Project Map
370 FRANKLIN ROAD
FRANKLIN, WILLIAMSON COUNTY, TENNESSEE

Pre-Application Conference Meeting Notes

Purpose: Envision Franklin Plan Amendment Request
Site: South side of Franklin Road/Mack Hatcher Parkway intersection
Attendees--
Staff: Kelly Dannenfelser, Amy Diaz-Barriga, Andrew Orr, Brad Baumgartner
Applicant: Dwight Kiser, Gary Vogrin, and Eric Flynn

ENVISION FRANKLIN | Design Concepts
FIGURE 4.1: DESIGN CONCEPTS MAP

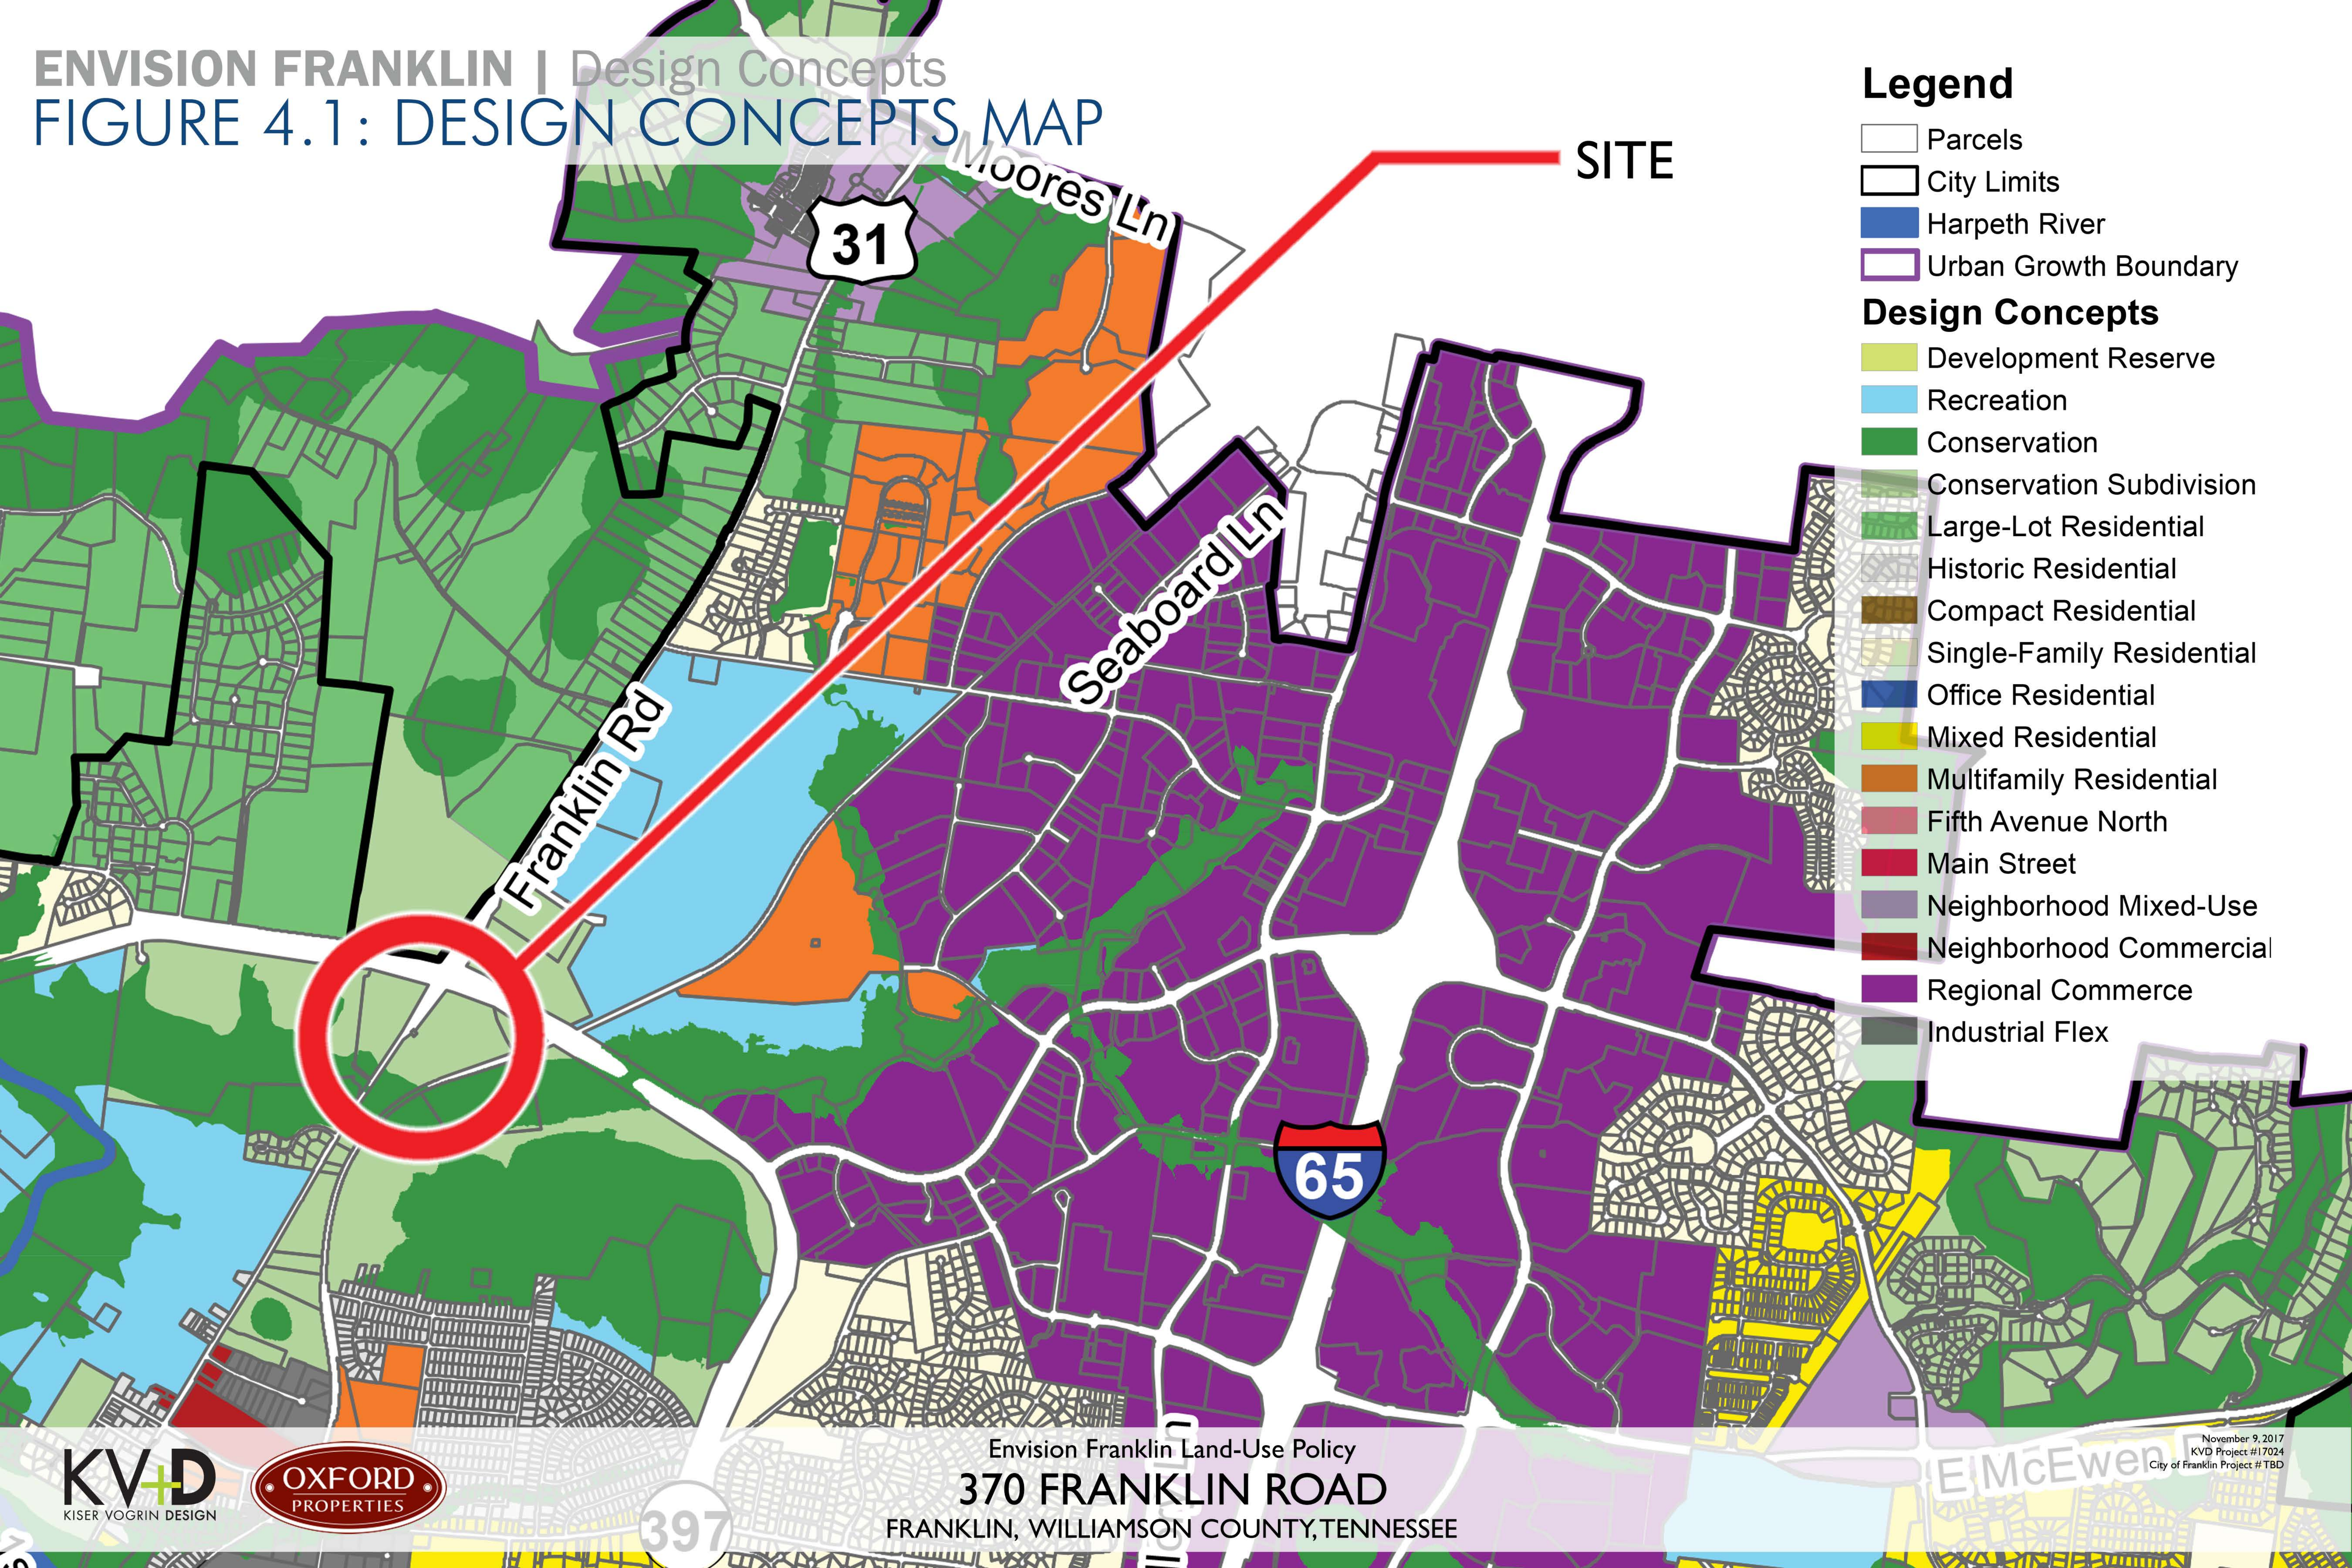
- They talked about doing a big house concept for the light yellow “buildings” along Franklin Road and townhomes behind it on the east side, with a row of single-family residential along Daniel McMahon Lane. They would keep the 150-foot building setback (but have parallel drives within it, which is not allowed by CFCO District.)

- We talked about the rural corridor, the 150-setback, and rural feel. The sense of place matters within a development and townhomes are incongruent with the established rural character, one that Harlinsdale Manor has set. KVD contends that the townhomes set back behind the Big Houses will have limited visibility from Franklin Road.
